Document Number: NA	Document Title: Briefings to LFRG on EMDF Performance Assessment and Composite Analysis		
Organization/Project: UCOR/EMDF	Comment Due Date:

Reviewer	TDEC
-----------------	------

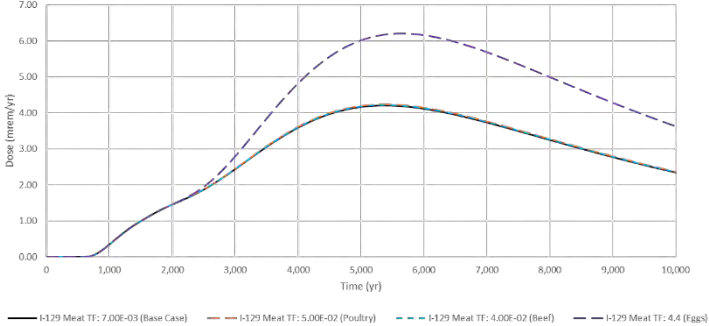
Comment No.	Presentation Slide	Comment/Suggested Change/Rationale	Response															
27	Slides 15 and 16	TFs are only considered for Tc99, not I129 or others. What is the basis for assuming I129 and others behaves the same way?	<p>Discussed September 20.</p> <p>As performed for Tc-99, additional simulations have been completed with varying transfer factors for I-129. Results are presented below.</p> <p>Refer to Sect. 3.4.5.1 of the revised PA for description of the basis for transfer factors used in the final dose analysis.</p>

<table><tr> <th>Transfer Factor</th> <th>Maximum Total Dose, Compliance Period (mrem/yr)</th> <th>Maximum Total Dose, 10,000 yrs (mrem/yr)</th> </tr><tr> <td>I-129 Meat TF: 7.00E-03 (Base Case)</td> <td>0.36</td> <td>4.21</td> </tr><tr> <td>I-129 Meat TF: 5.00E-02 (Poultry)</td> <td>0.36</td> <td>4.23</td> </tr><tr> <td>I-129 Meat TF: 4.00E-02 (Beef)</td> <td>0.36</td> <td>4.23</td> </tr><tr> <td>I-129 Meat TF: 4.4 (Eggs)</td> <td>0.36</td> <td>6.21</td> </tr></table>

<p data-bbox="1444 943 1766 959">All Pathways Dose Sensitivity to I-129 Meat Transfer Factor</p>  <p data-bbox="1262 1287 1959 1300"> — I-129 Meat TF: 7.00E-03 (Base Case) - - - I-129 Meat TF: 5.00E-02 (Poultry) - - - I-129 Meat TF: 4.00E-02 (Beef) - - - I-129 Meat TF: 4.4 (Eggs) </p>	Transfer Factor	Maximum Total Dose, Compliance Period (mrem/yr)	Maximum Total Dose, 10,000 yrs (mrem/yr)	I-129 Meat TF: 7.00E-03 (Base Case)	0.36	4.21	I-129 Meat TF: 5.00E-02 (Poultry)	0.36	4.23	I-129 Meat TF: 4.00E-02 (Beef)	0.36	4.23	I-129 Meat TF: 4.4 (Eggs)	0.36	6.21
Transfer Factor	Maximum Total Dose, Compliance Period (mrem/yr)	Maximum Total Dose, 10,000 yrs (mrem/yr)																
I-129 Meat TF: 7.00E-03 (Base Case)	0.36	4.21																
I-129 Meat TF: 5.00E-02 (Poultry)	0.36	4.23																
I-129 Meat TF: 4.00E-02 (Beef)	0.36	4.23																
I-129 Meat TF: 4.4 (Eggs)	0.36	6.21
